Service Letter

SL03-420/ERO  
February 2003

**Crankcase Relief Valves**

*Fig.1: Shields fitted around crankcase relief valves*

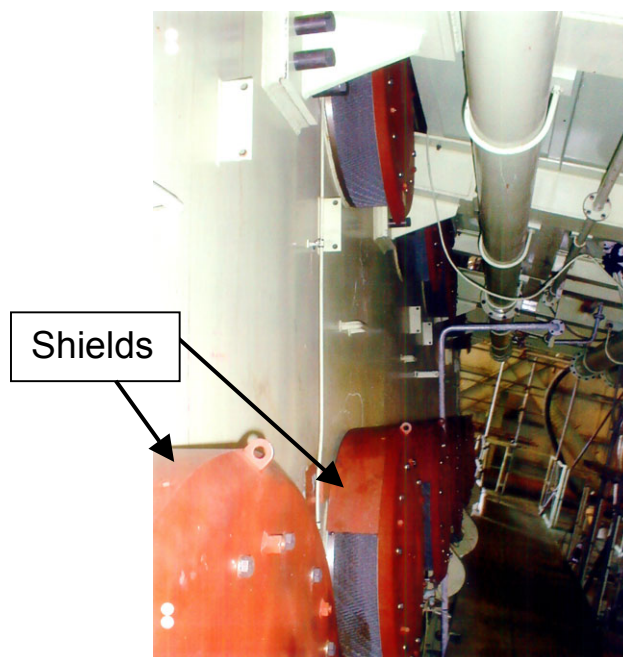
However, it has recently been brought to our attention that some ships in service have shields mounted on or around the crankcase relief valves. An example is shown in Fig. 1.

We strongly advise against the use of such shields as they will have a negative effect. The oil mist will still move towards the turbocharger(s) anyway and, even worse, the shielding will spoil the effect of an, otherwise, well-functioning flame arrester.

Based on this experience, we recommend that you check the relief valves on your engines and if equipped with such shields, we recommend that these be removed as soon as possible.
